PUBLIC INTEREST REVIEW FOR GROUND WATER APPLICATIONS

SUBJECT: Application G- 17724 and LL 1501 Supersedes review of n/a
Date of Review(s)

A. GENERAL INFORMATION: Applicant's Name: Teevin Bros. Land and Timber County: Columbia

Output for Hunt Stream Depletion, Scenerio 2 (s2):

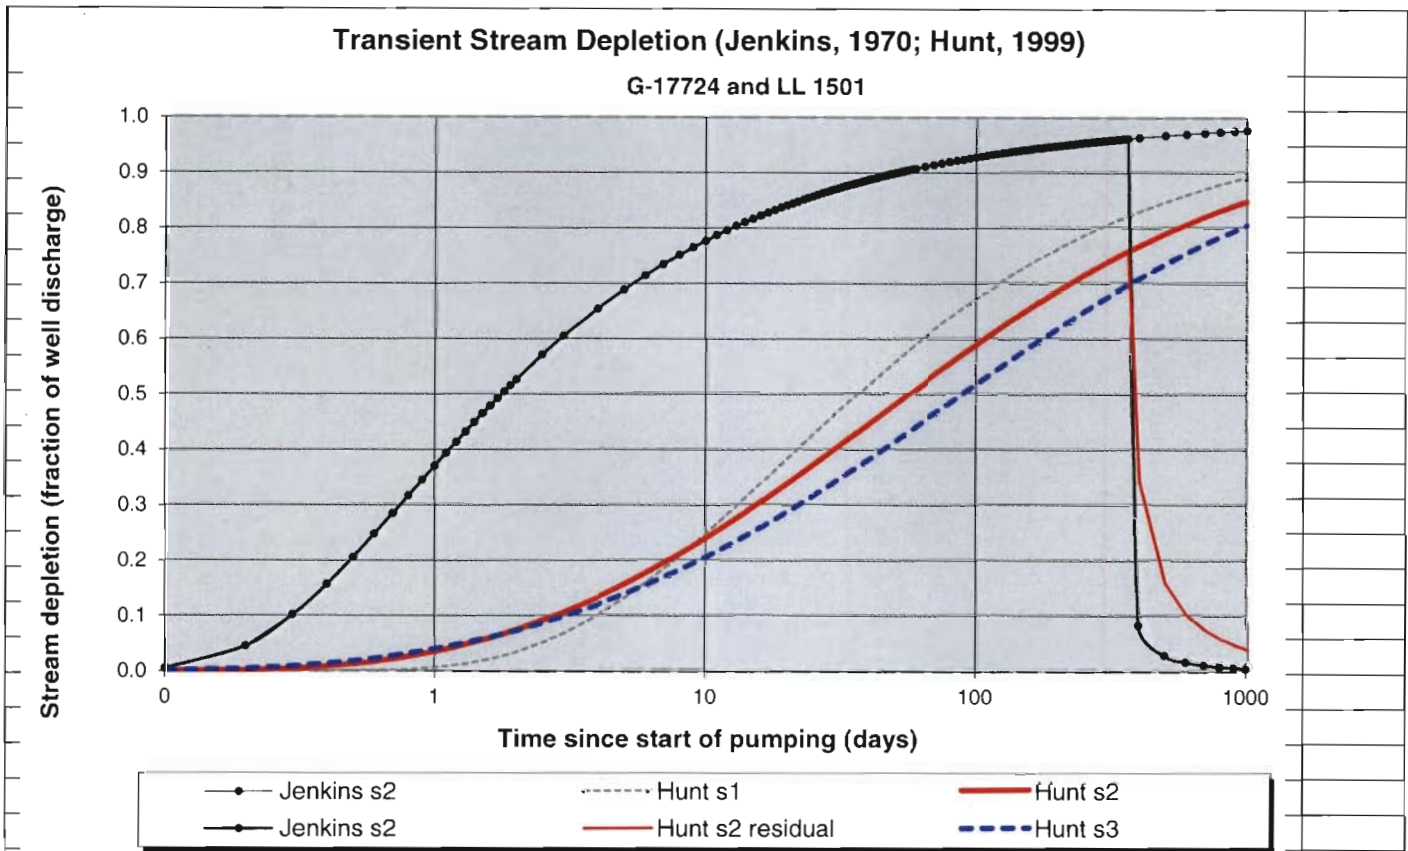
Comments: *Interference was estimated using a range of potential aquifer parameters for an unconfined sand and gravel aquifer. Even the most conservative estimates of aquifer parameters produce stream depletion > 25 % at 30 days.
